# HISTORIC AND DESIGN REVIEW COMMISSION

May 04, 2022

**HDRC CASE NO:** 2022-239  
**ADDRESS:** 702 HAYS ST  
**LEGAL DESCRIPTION:** NCB 540 BLK 11 LOT A16  
**ZONING:** R-5, H  
**CITY COUNCIL DIST.:** 2  
**DISTRICT:** Dignowity Hill Historic District  
**APPLICANT:** Kuba Zarobkiewicz/ZAROBKIEWICZ KUBA  
**OWNER:** Kuba Zarobkiewicz/ZAROBKIEWICZ KUBA  
**TYPE OF WORK:** Construction of a rear addition  
**APPLICATION RECEIVED:** April 04, 2022  
**60-DAY REVIEW:** Not applicable due to City Council Emergency Orders  
**CASE MANAGER:** Rachel Rettaliata

**1 FRONT ELEVATION**  
SCALE: 1/4" = 1'-0"

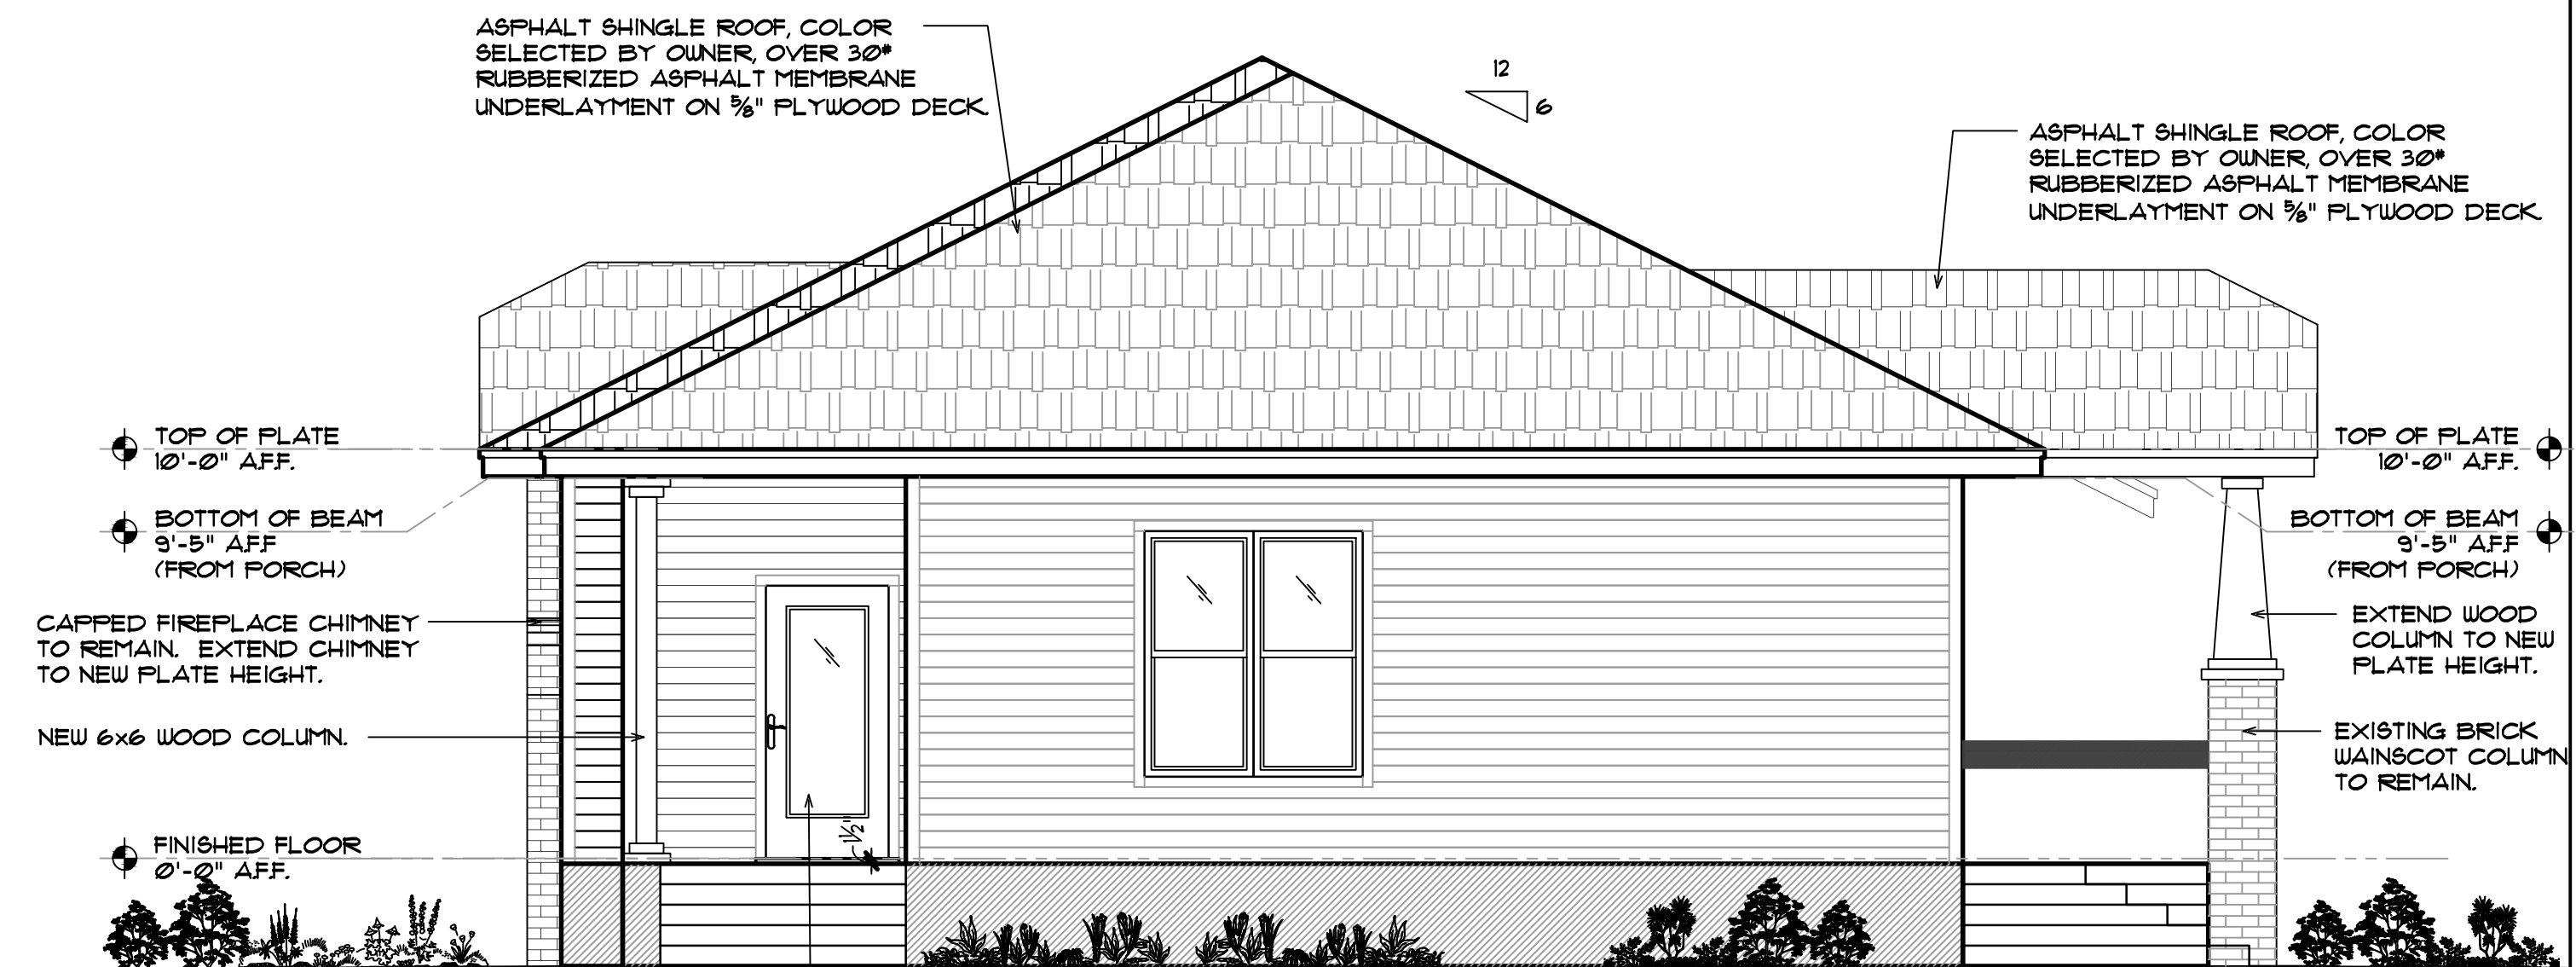
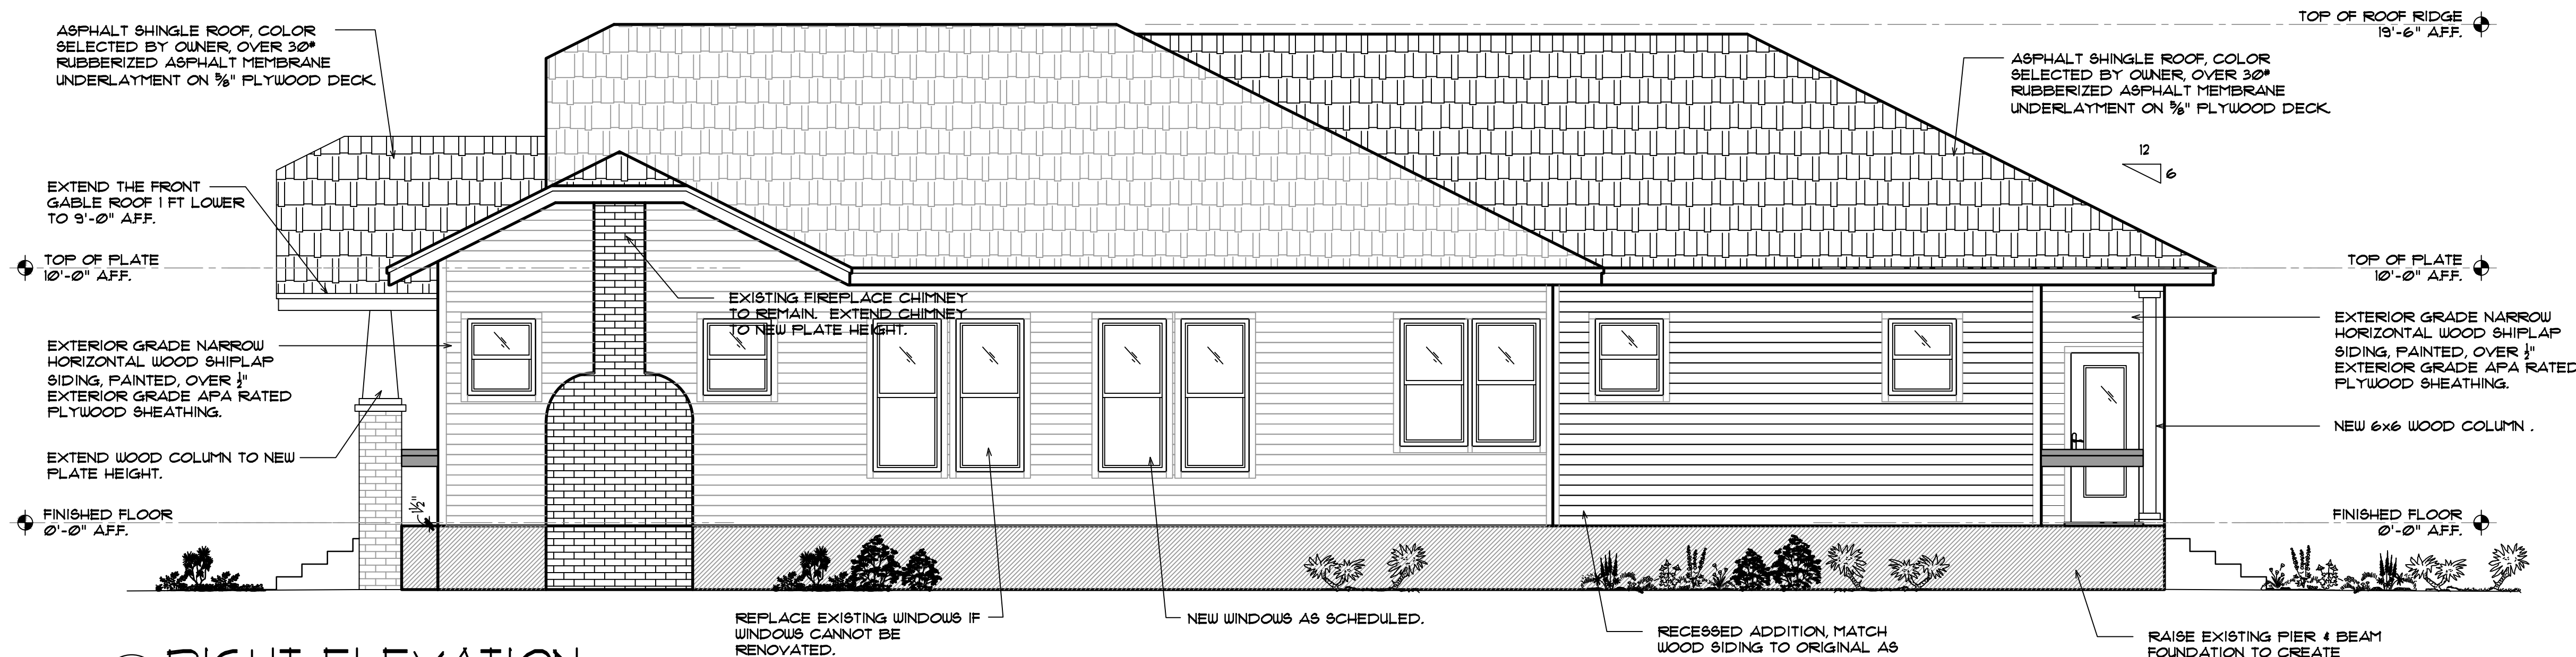
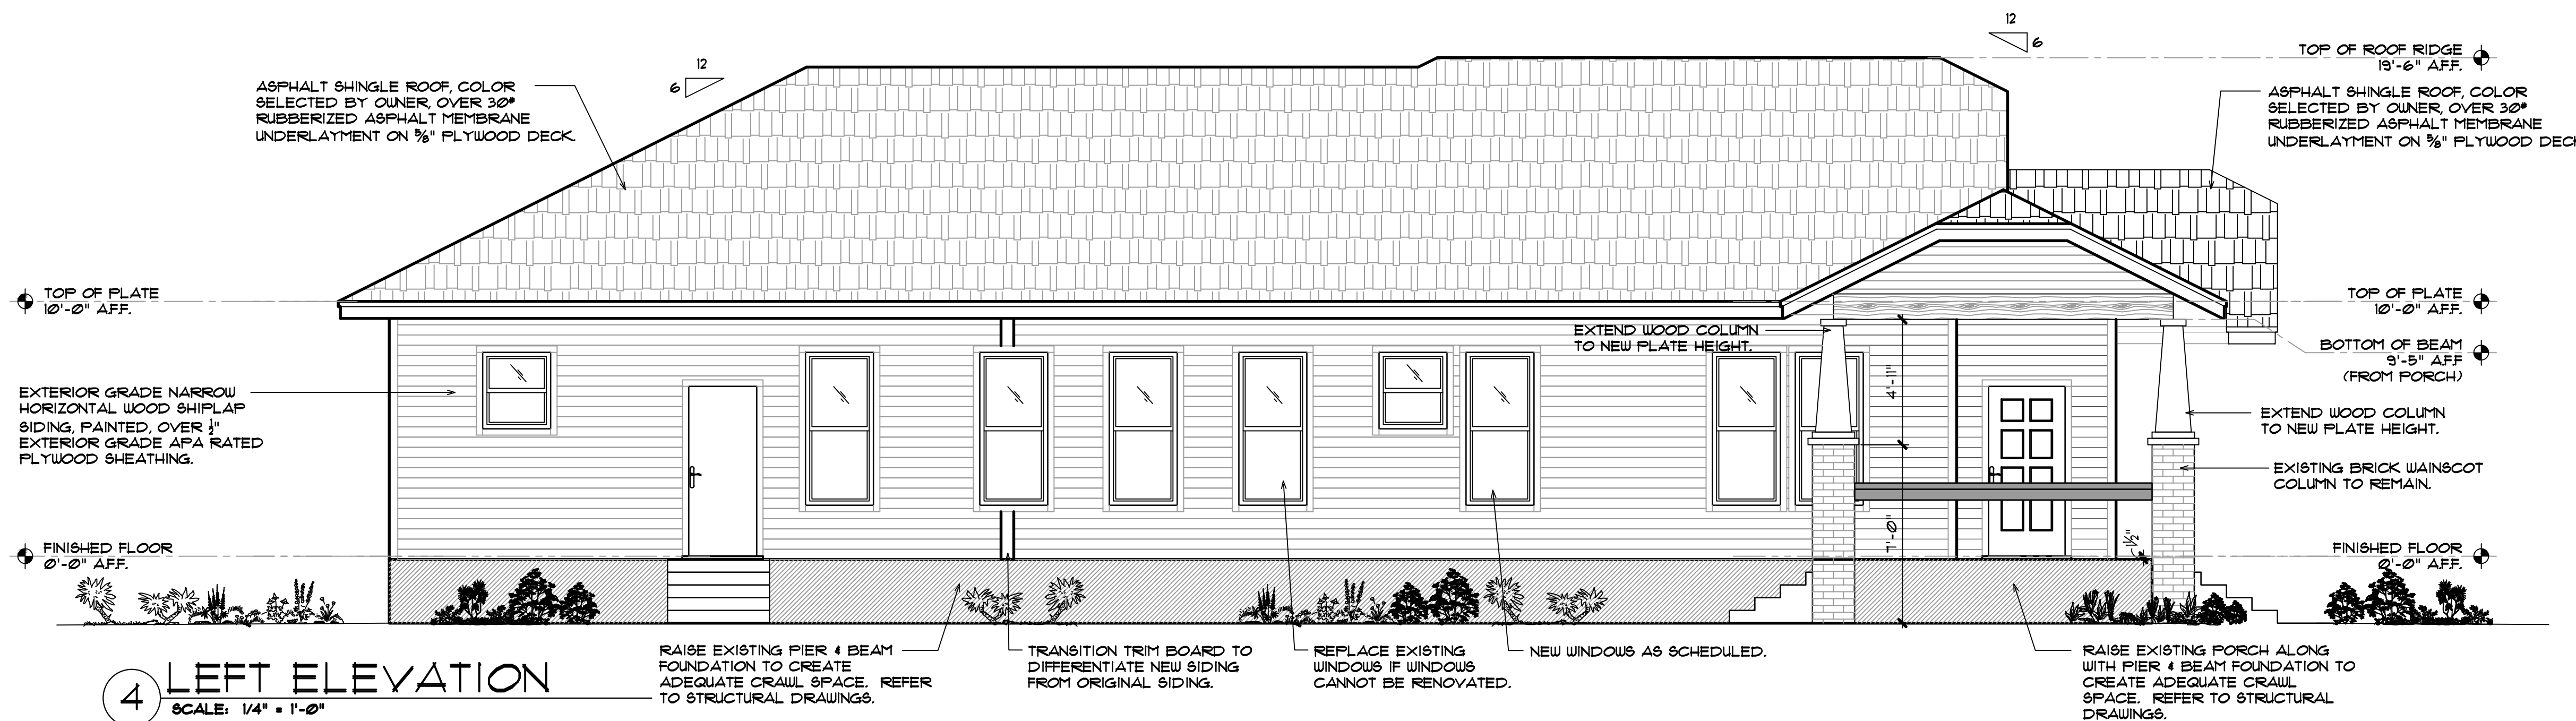
- c. FLOOR HEIGHT/PORCH GABLE – The applicant has proposed to raise the existing finished floor height and extend the existing gabled porch roof by one foot on each side. Staff finds this to be inappropriate with the Guidelines for Exterior Maintenance and Alterations, as the Guidelines note that historic porch forms should not be modified and that the original height of foundations should be preserved.

- i. ROOF FORM – The applicant has proposed for the rear addition to feature a hipped roof. Generally, staff finds the proposed hipped roof form to be appropriate.

- j. ARCHITECTURAL DETAILS – Generally staff finds the proposed architectural details to be appropriate; however, staff finds that the construction of a rear addition should not result in an increase in height of the original structure's finished floor/foundation height.

1. Staff recommends approval of item #1, rehabilitative scopes of work based on finding b with the stipulation that that the profile and details of the existing roof, including the porch roof be preserved.
2. Staff does not recommend approval of item #2, modifications to the finished floor/foundation height and porch roof modifications. Staff recommends both remain as they exist originally.
3. Staff does not recommend approval of item #3, window replacement. Staff recommends that the existing wood windows should be repaired. If wood windows are beyond repair, they should be replaced with windows that are consistent with staff's standards for replacement windows. A Certificate of Appropriateness is required for window replacement.
4. Staff recommends approval of item #4, the construction of a rear addition based on findings e through j with the following stipulations:
